**California Endangered Species Act
Amended Incidental Take Permit No. 2081-2021-015-06
(Amendment No. 5)**

CRIMSON SOLAR PROJECT

CDFW now reissues this ITP including the revised provisions in this Major Amendment (Collectively, the Amended ITP). The Amended ITP includes all of the operative provisions as of the effective date of this Amended ITP. Attachment 11 to this Amended ITP shows the specific red-line changes made to the ITP as a result of this Major Amendment.

Figure 4b: Site Plans with Borrow Pit Locations

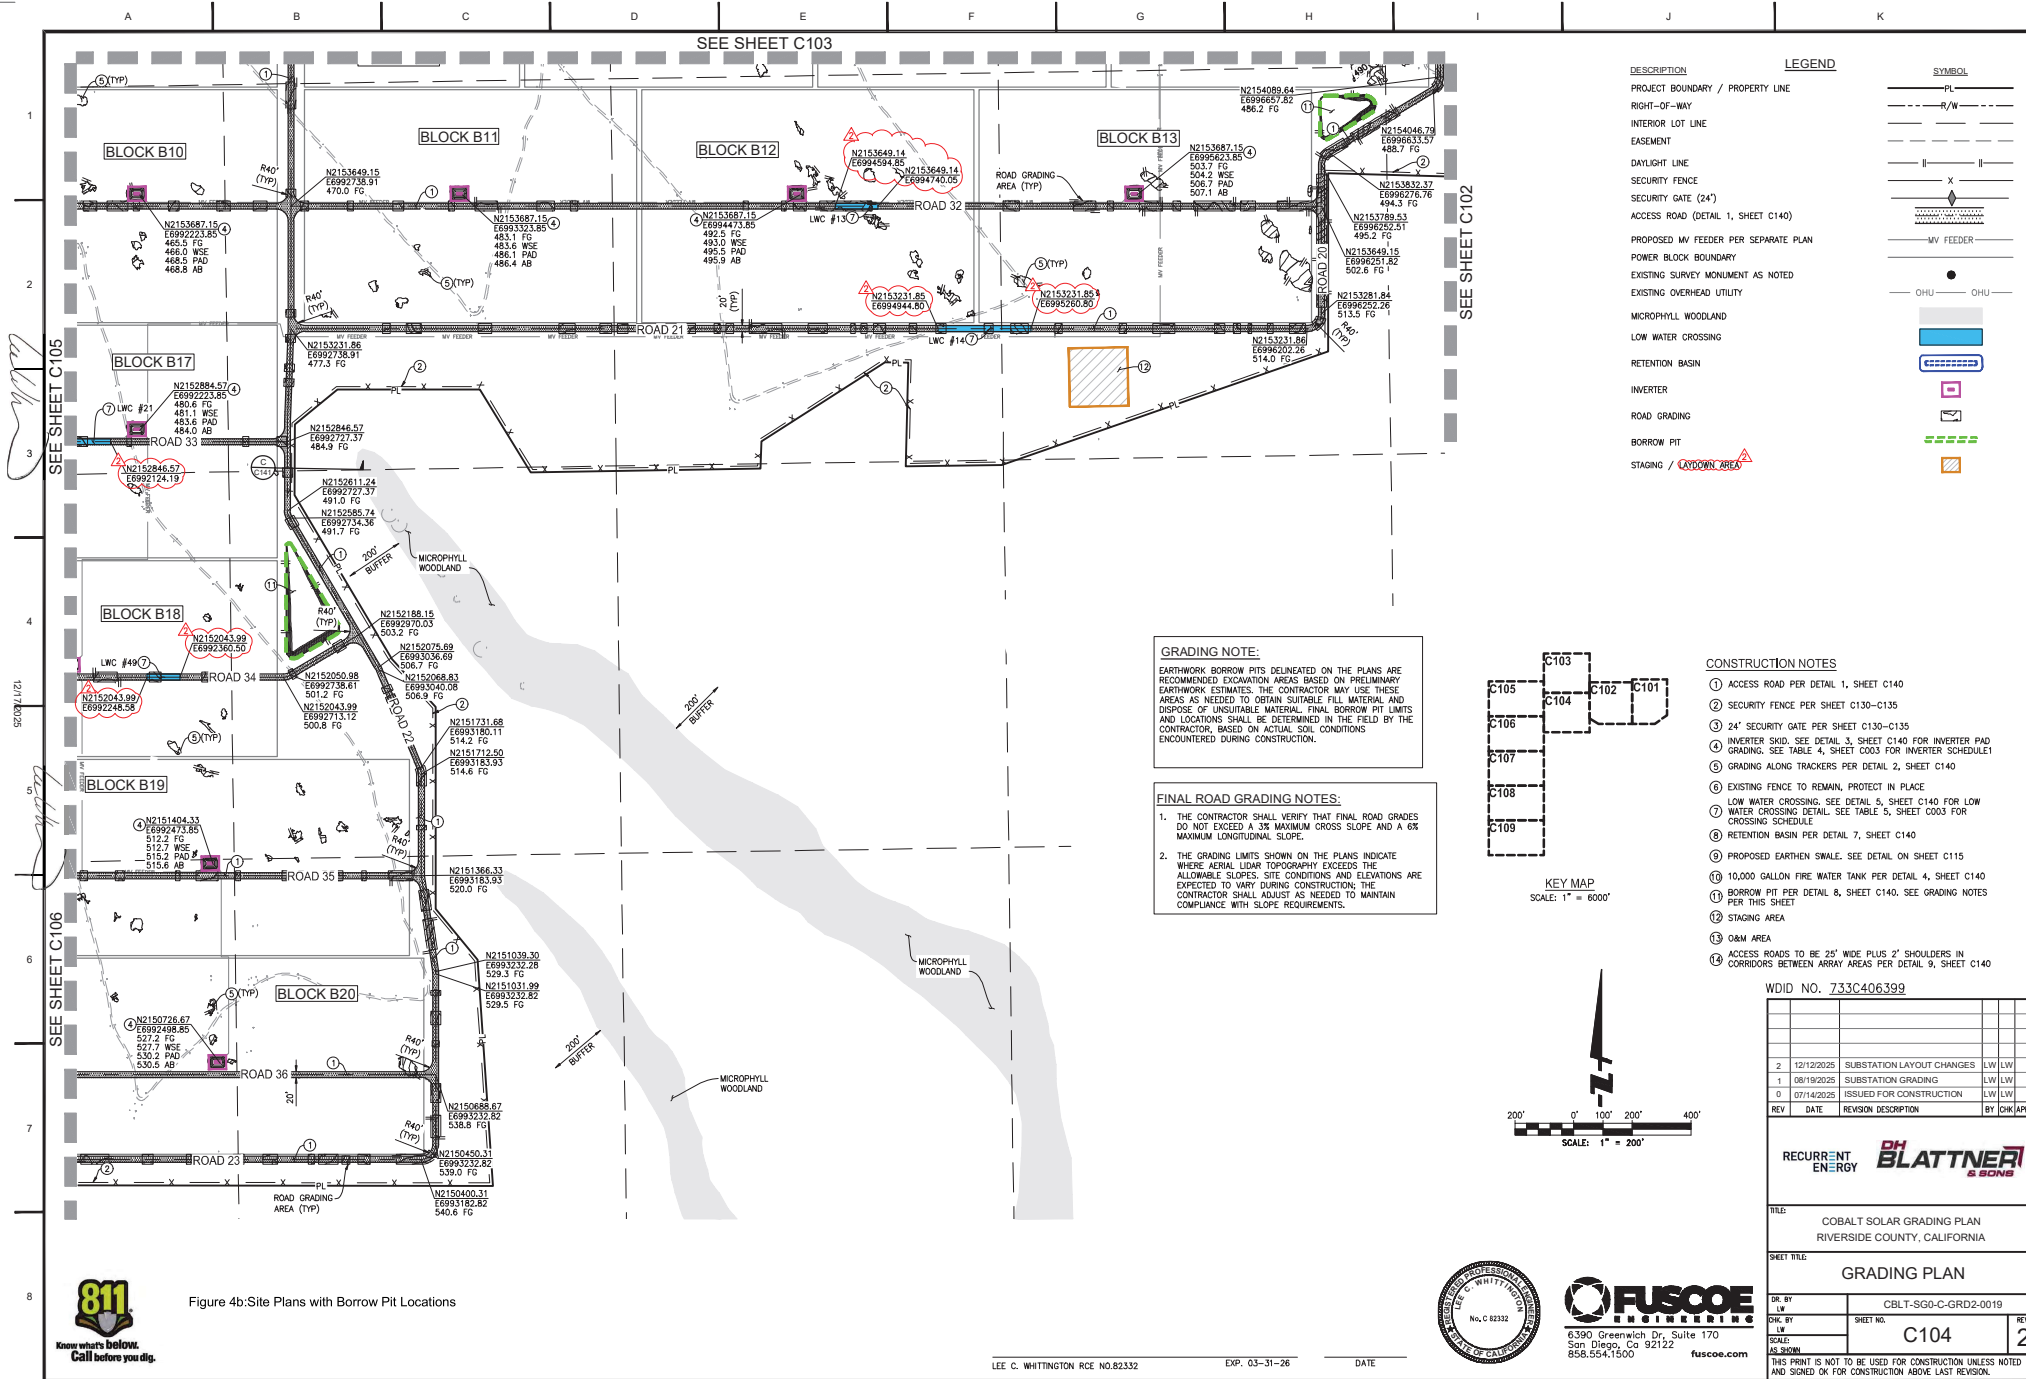
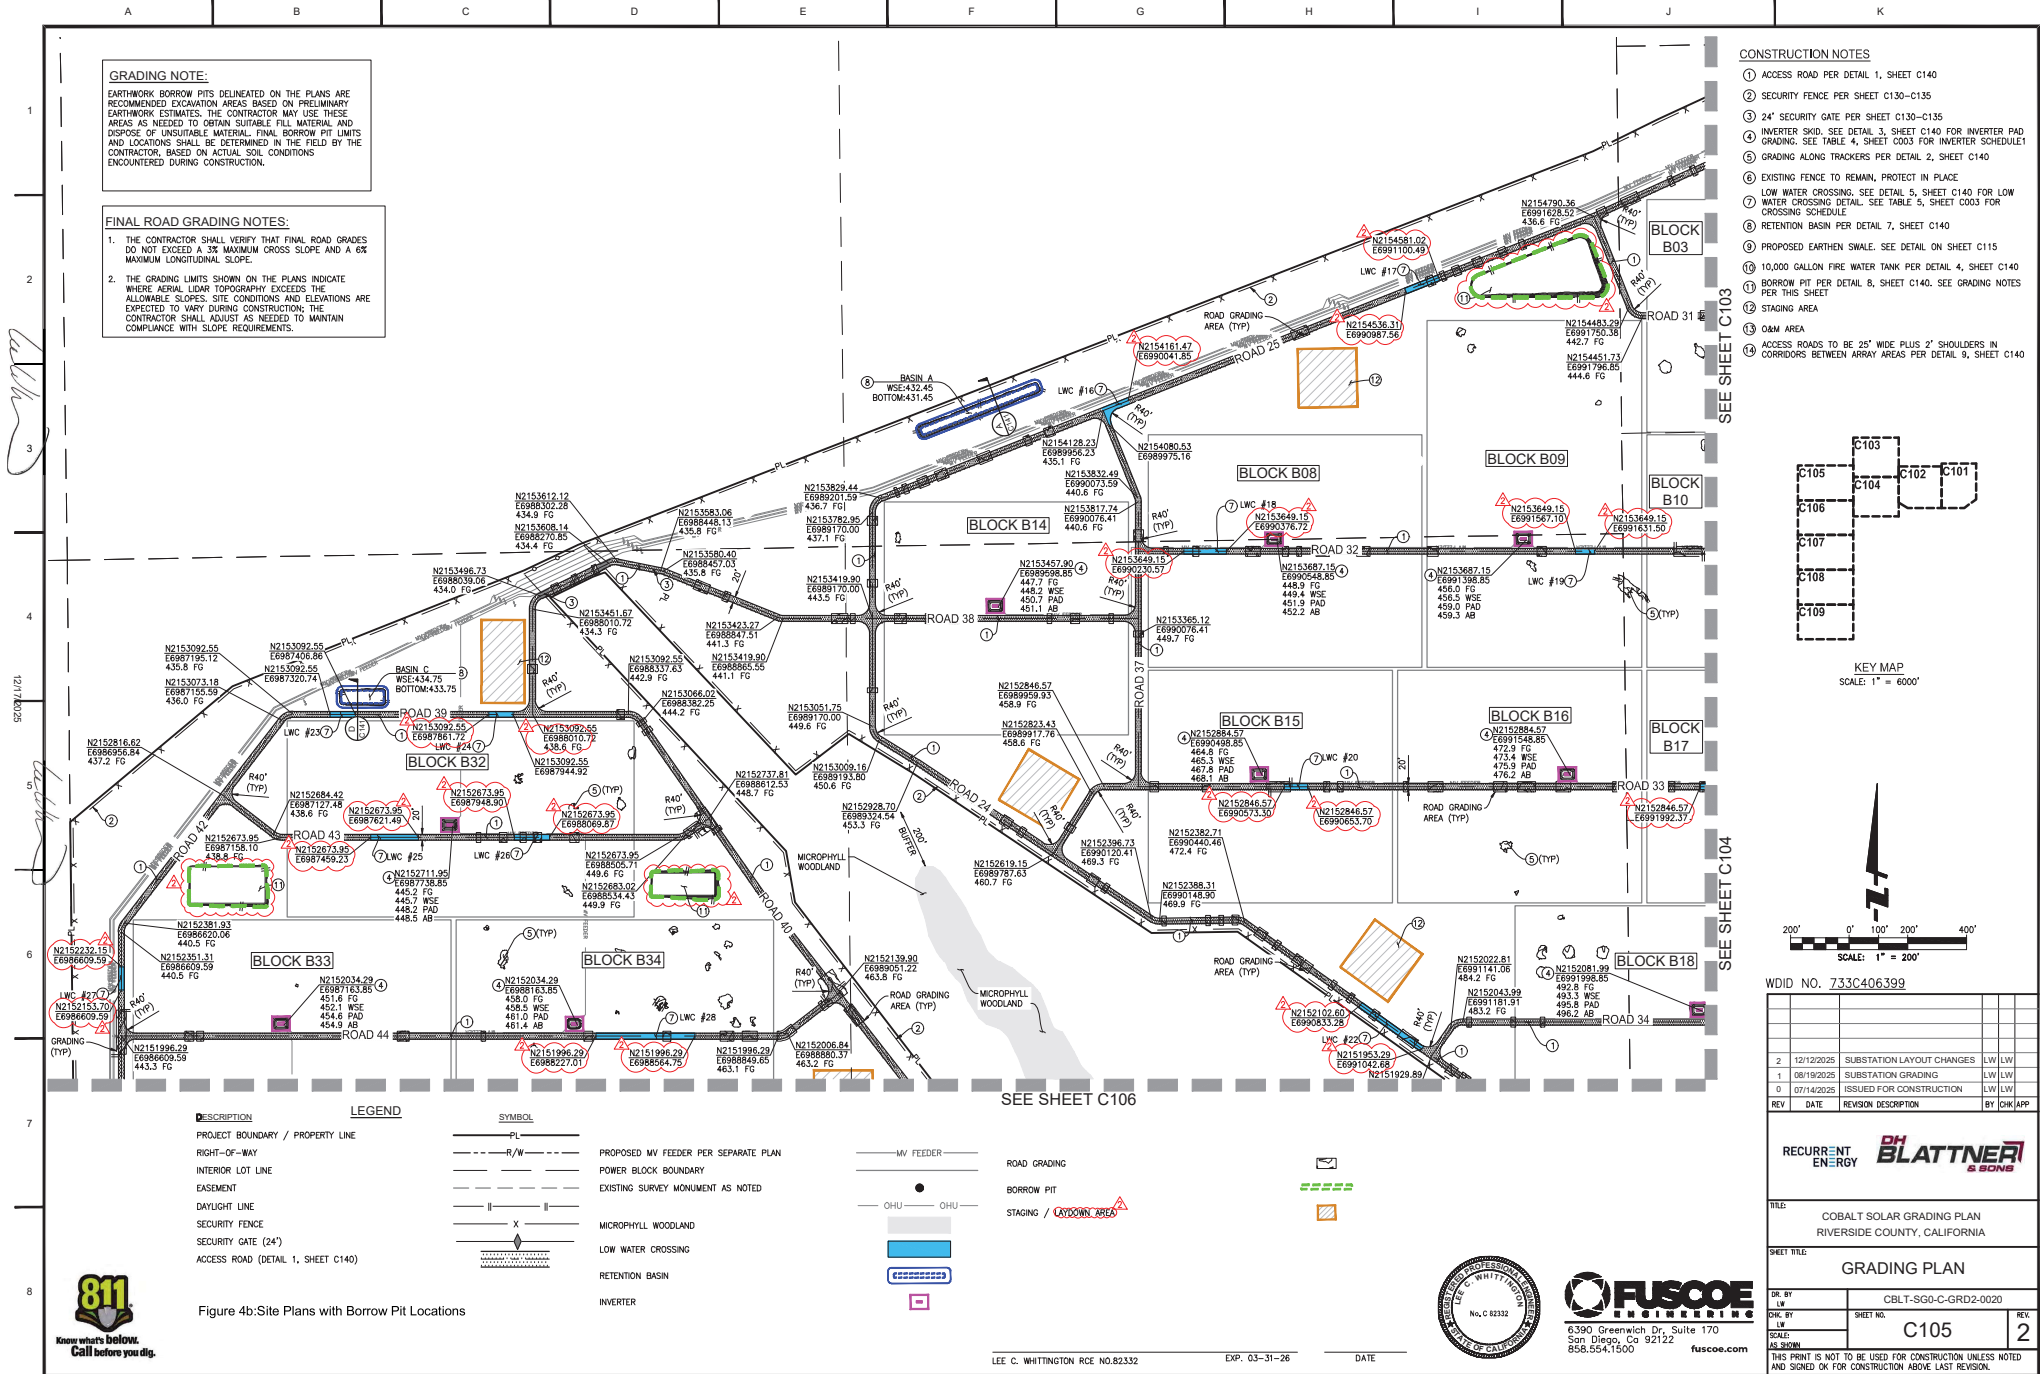
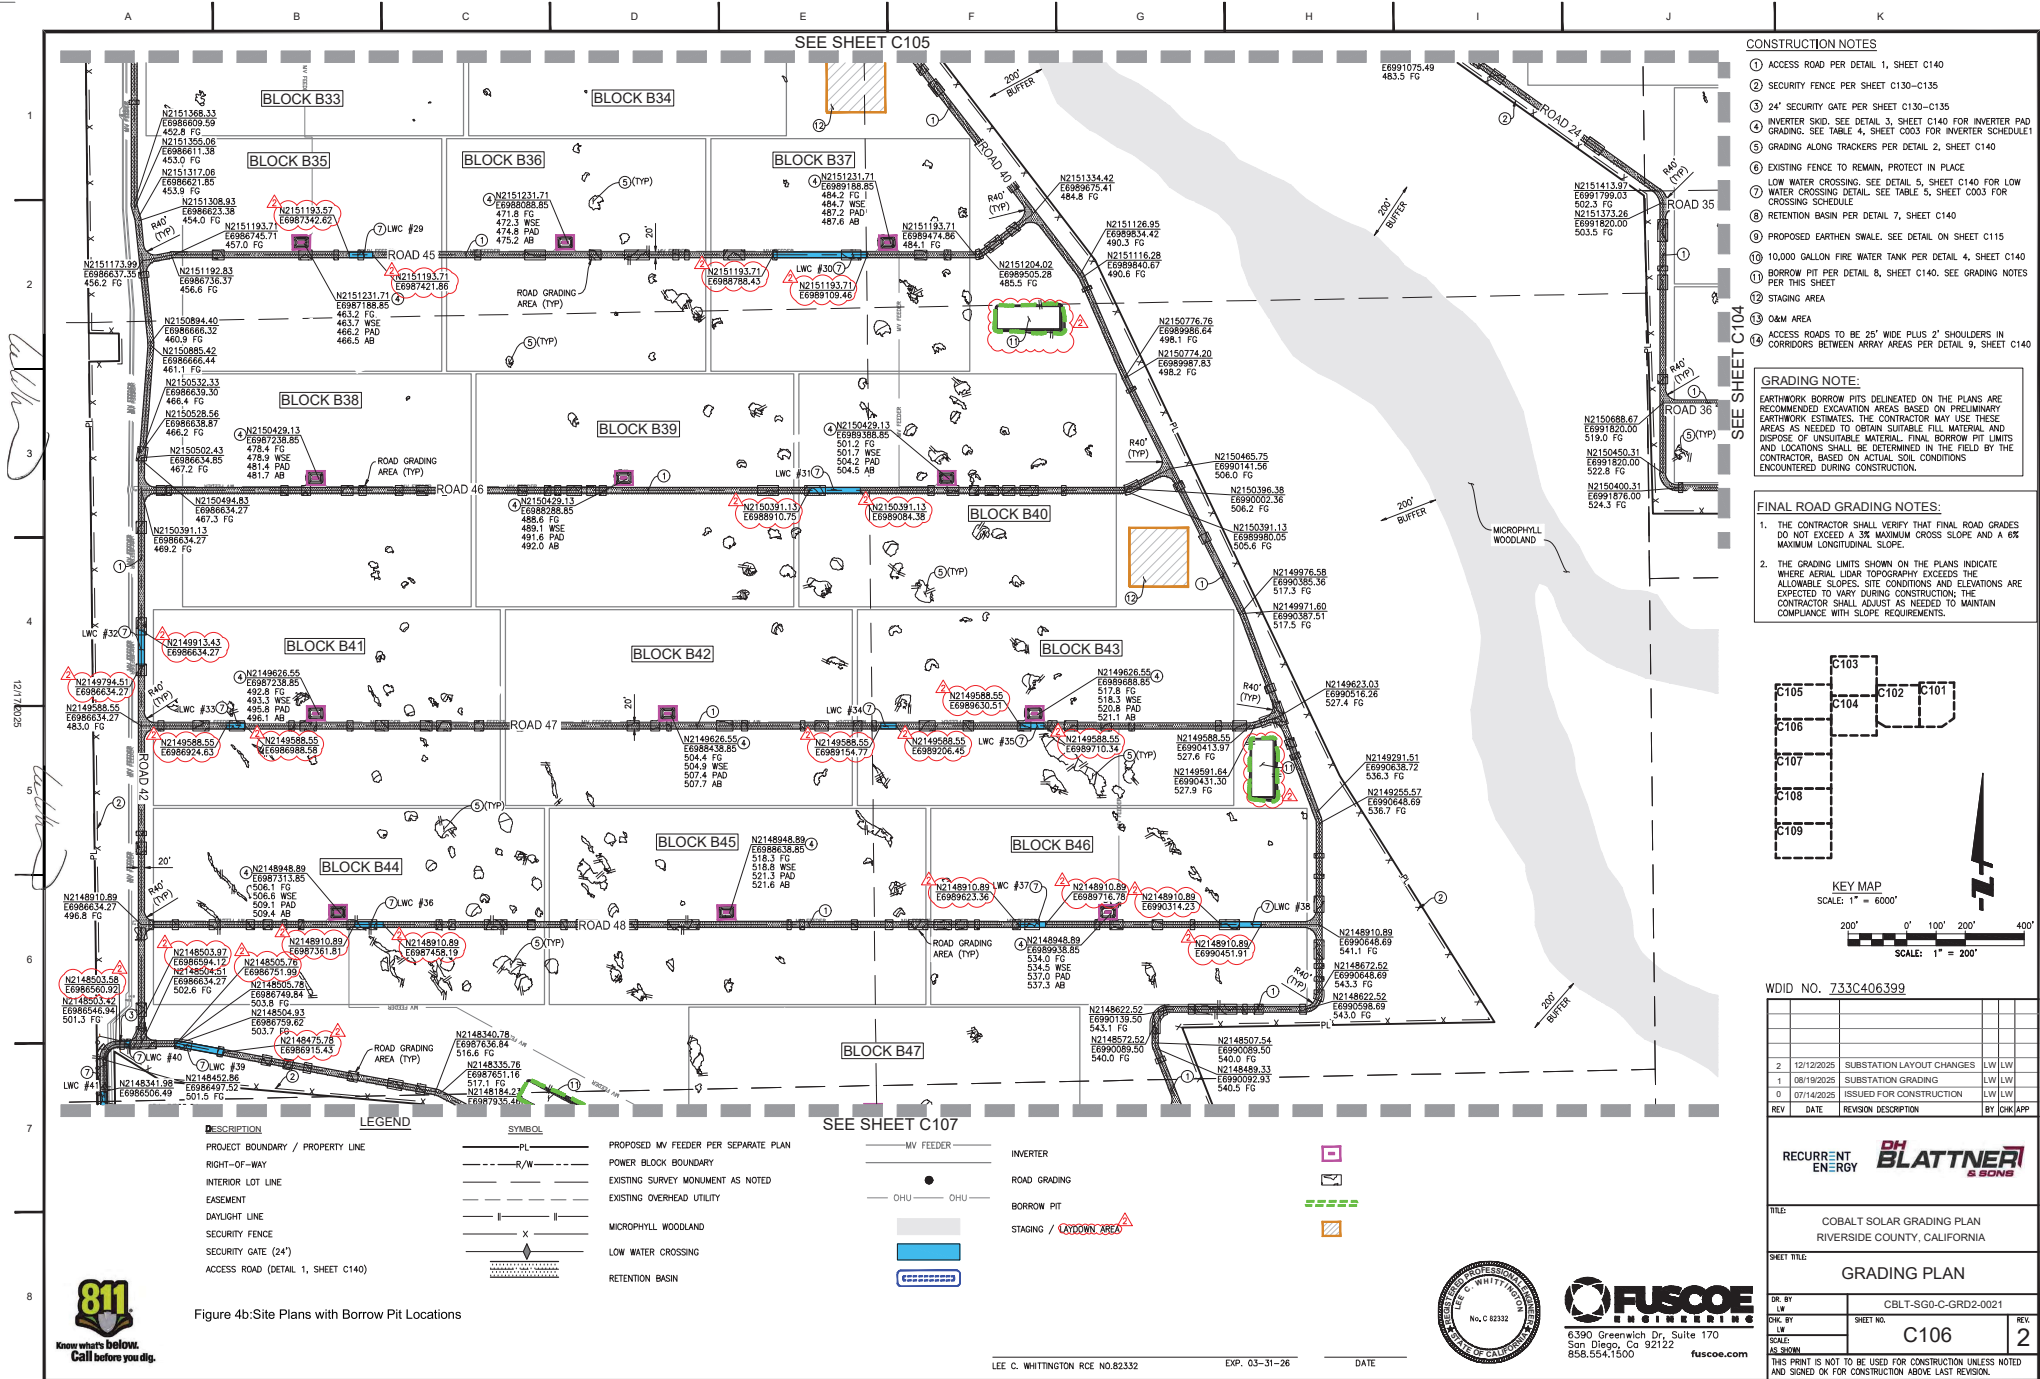
- (1) Updates to the Project Description to include the addition of borrow pits in the solar array area and modification of Condition of Approval 8.19 Borrow Pits to remove the language prohibiting borrow pit use and outlining a minimization measure for use of borrow pits.

The Project would establish up to twenty-five borrow pits distributed across the fenced solar array fields to source native fill material that would be needed for the construction of Project components such as access roads, inverter pads, sub-station pads, and O&M buildings (Figure 4b). Each borrow pit would be approximately 0.5 acres, totaling up to 12.5 acres of

borrow pit sites. Following extraction of native fill material, borrow pits would be recontoured and revegetated consistent with the surrounding landscape. Topsoil would be harvested at each borrow pit and temporarily stockpiled until after fill material is extracted. Structural fill material would then be excavated from the pit to achieve gradual 3:1 side slopes to depths ranging from 1 foot to up to 12 feet, depending on fill quality and topography at each borrow pit location (Figure 5). Once borrow pit excavation is complete, the borrow pit area would be regraded to achieve more natural slopes that tie into the surrounding landscape. Following recontouring, the stockpiled topsoil would be spread across the restored area and revegetated with native species consistent with the surrounding landscape.

DETAIL 8 - BORROW PIT
NOT TO SCALE

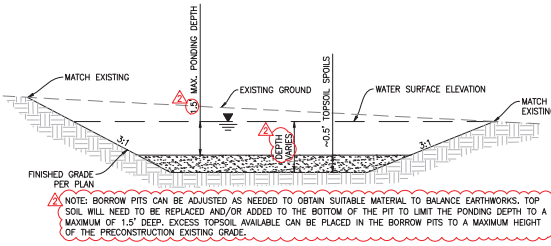
The Project would establish up to twenty-five borrow pits distributed across the fenced solar array fields to source native fill material that would be needed for the construction of Project components such as access roads, inverter pads, sub-station pads, and O&M buildings (Figure 4b). Each borrow pit would be approximately 0.5 acres, totaling up to 12.5 acres of borrow pit sites. Following extraction of native fill material, borrow pits would be recontoured and revegetated consistent with the surrounding landscape. Topsoil would be harvested at each borrow pit and temporarily stockpiled until after fill material is extracted. Structural fill material would then be excavated from the pit to achieve gradual 3:1 side slopes to depths

ranging from 1 foot to up to 12 feet, depending on fill quality and topography at each borrow pit location (Figure 5). Once borrow pit excavation is complete, the borrow pit area would be regraded to achieve more natural slopes that tie into the surrounding landscape. Following recontouring, the stockpiled topsoil would be spread across the restored area and revegetated with native species consistent with the surrounding landscape.

Biologist(s) at least daily. All borrow pits shall be located in upland areas outside of microphyll woodland and ephemeral washes. Dumping of construction material into borrow pits is not covered by this ITP. The slope of the borrow pits shall be contoured to and remain at a 30% angle for the term of this ITP to prevent wildlife entrapment. Revegetation shall follow condition of approval 8.25. During O&M, the slope of the borrow pits shall be inspected by the Authorized Biologist(s) during monthly compliance visits and shall report any maintenance needs to the Permittee.
